**SERVICE BULLETIN**

**N° 139-647**

**ATA 53 - INTERSEAT CONSOLE CONNECTORS REPOSITIONING**

AW139 helicopter S/N 31133.

**Figure 1**

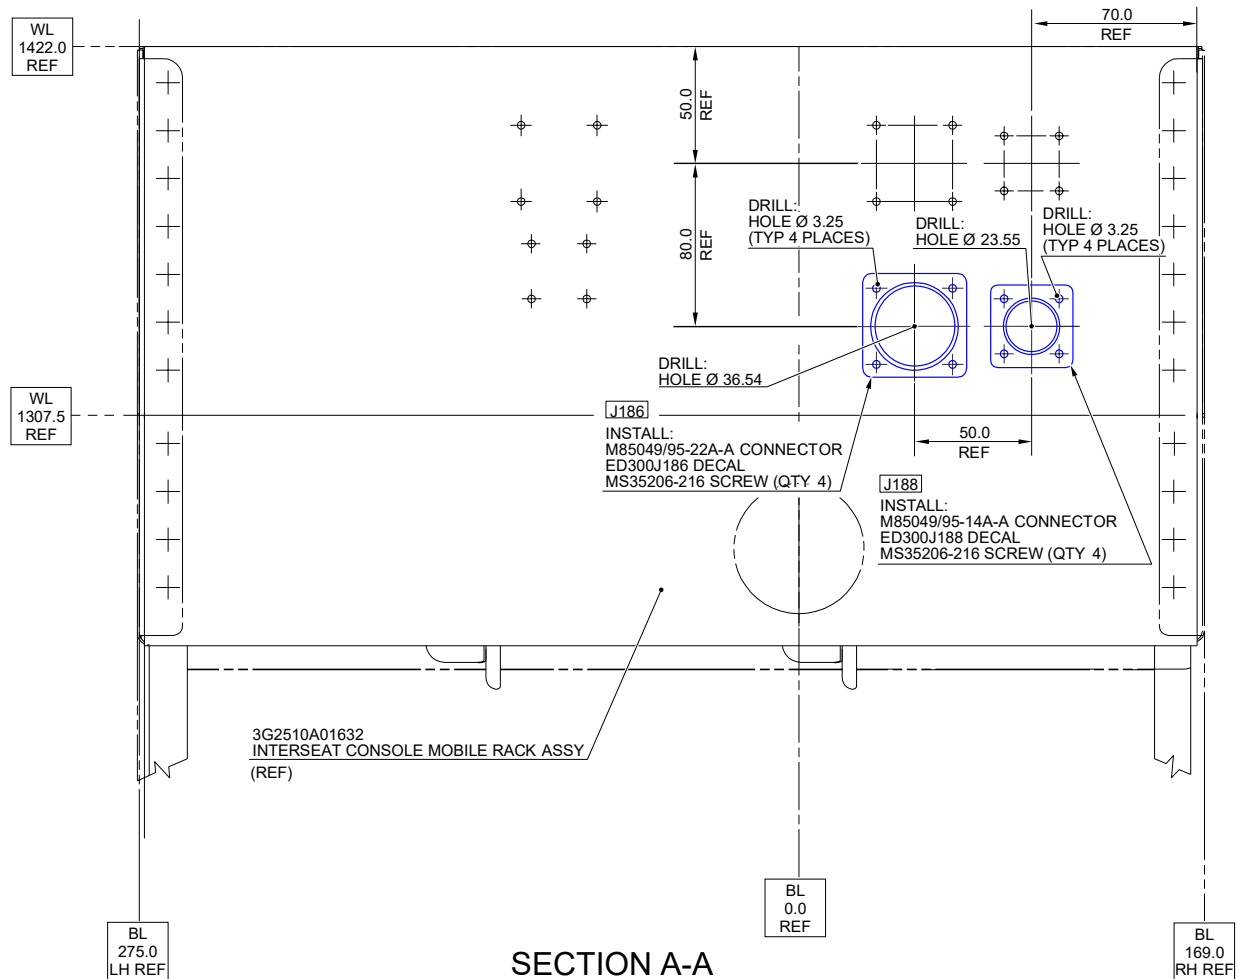
This Service Bulletin is issued in order to provide the necessary instruction on how to perform the repositioning of connectors J186 and J188 on the I/C.

Leonardo Helicopter has developed this Service Bulletin in order to permit a deviation on the installation of the two connectors J186 and J188 part of the EMS (MEDEVAC) electrical provision. The repositioning, on a lower position on the interseat console, is necessary due to the interference between the backshells of the two connectors and the Console Storage Unit also installed on the I/C.

2. With reference to Figure 1 and in accordance with AMP DM 39-A-06-41-00-00A-010A-A, gain access to the area affected by the installation.
  3. With reference to Figure 1 Section A-A drill a hole Ø36.54 thru the aft frame of the interseat console in accordance with the position shown.

4. With reference to Figure 1 Section A-A drill a hole Ø23.55 thru the aft frame of the interseat console in accordance with the position shown.
  5. With reference to Figure 1 Section A-A drill n°8 holes Ø3.25 thru the aft frame of the interseat console in accordance with the position shown and with the two connectors J186 and J188.

6. With reference to Figure 1 Section A-A, install the two connectors J186 and J188 on the aft frame of the interseat console by means of n°8 screws P/N MS35206-216.

7. With reference to Figure 1 Section A-A and in accordance with AMP DM 39-A-11-00-01-00A-720A-A, install the decals P/N ED300J188 and ED300J186.
  8. In accordance with weight and balance changes, update the Chart A (see Rotorcraft Flight Manual, Part II, section 6).
